LONG-TERM GROUNDWATER MONITORING WORK PLAN

**Byron Barrel and Drum Site
Genesee County, Byron Township, New York**

**September 2016
(Revised November 2016)**

Attachment B
Regulatory Comments and Responses

FIGURE 3

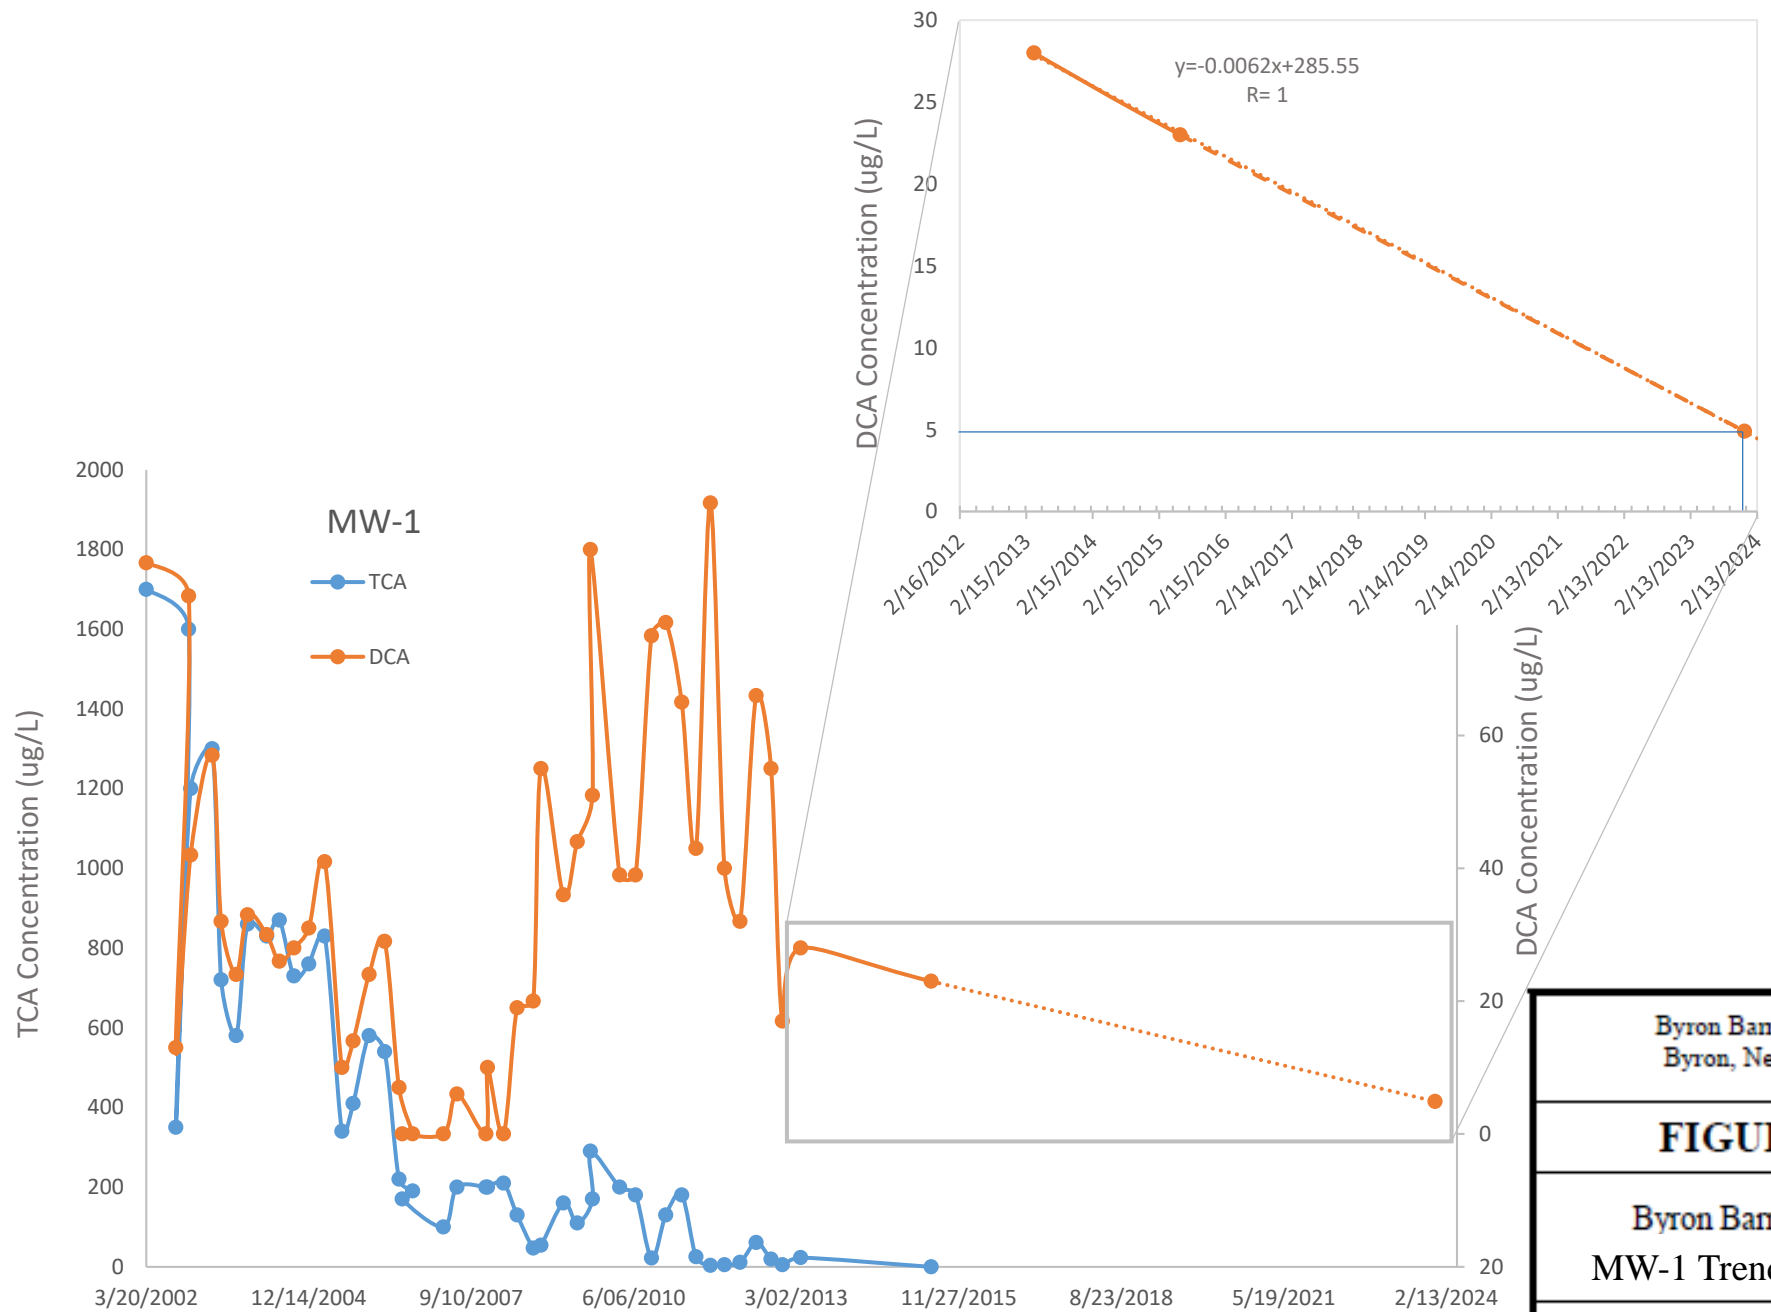
A) The FRPM trend analysis is within the range of the previously submitted analysis, and it appears to be reasonable. There is a low groundwater gradient in this area and there isn't much of a volume of groundwater flow. Additional and enhanced monitoring was suggested so that the trends could be updated to re-assess the estimated time for groundwater restoration. An active enhancement (such as ISCO) at the remaining impacted area will be appropriate to ensure the 2024 target date is met on time or before. Agencies support the idea that this decision be made after reviewing the November 2016 groundwater sampling data. *It appears that the groundwater constituents continue to be degraded as a result of previous remediation efforts. As indicated by the comment, remedial progress can continue to be monitored and evaluated.*
